SCHEME - TWO
PROPERTY ROTATED
WITH SHORTER BUILDING
DELETED ONE 12'-5 ½" BAY

LAQUINTA INN & SUITES

HATTIESBURG, MISSISSIPPI

SITE PLAN
SCHEME-2

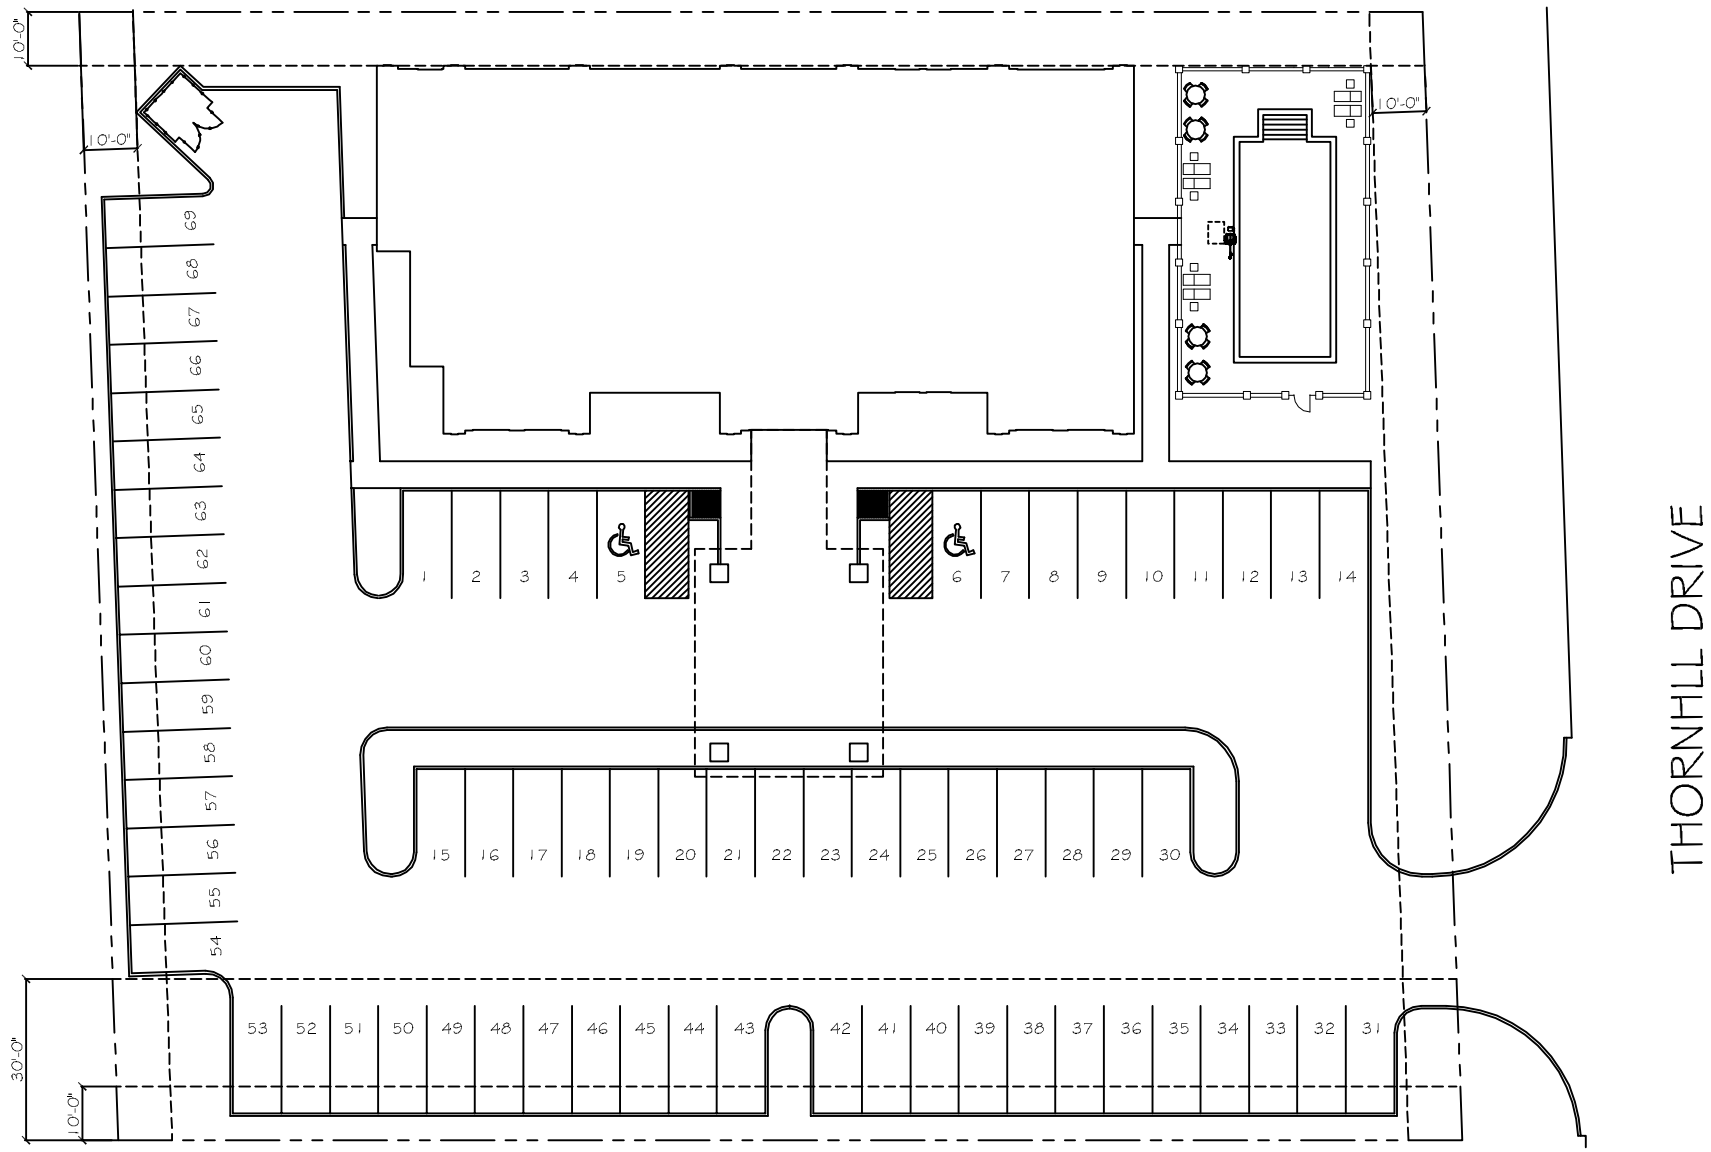
WROND SETBACK AT ROAD
SHOULD BE 30 FT. (NOT 10')
AND SHOULD BE NO PARKING
IN REAR & SIDE SETBACKS -
WONT WORK!
